DEPARTMENT OF TRANSPORTATION

National Highway Traffic Safety Administration

Federal Motor Vehicle Safety Standards; Platform Lifts for Motor Vehicles; Platform Lift Installations in Motor Vehicles

ACTION: Final rule.

FIGURE 2

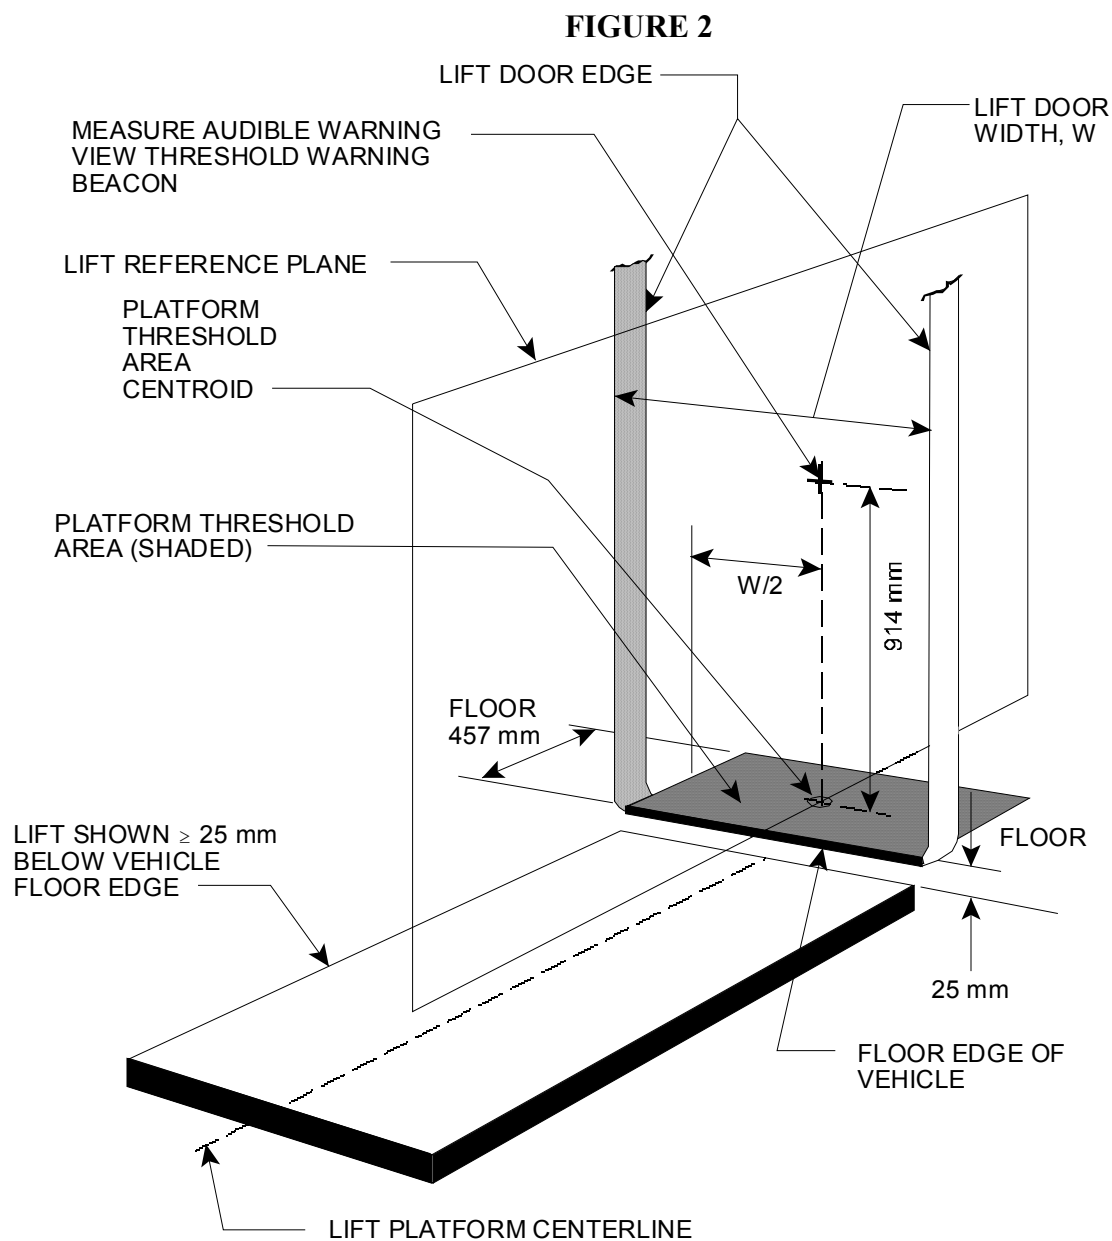
NHTSA also proposed a correction to Figure 2 of FMVSS No. 403. Currently, the height of the measurement point from which the intensity of the threshold audible warning is measured is identified as 919 mm. The proposed amendment would replace that distance with the correct measurement point of 914 mm (3 feet).

S6.1.6 The intensity of the audible warning and visibility of the visual warning required by S6.1.2 and S6.1.3 is measured/observed at a location 914 mm (3 ft) above the center of the platform threshold area. (See Figure 2).
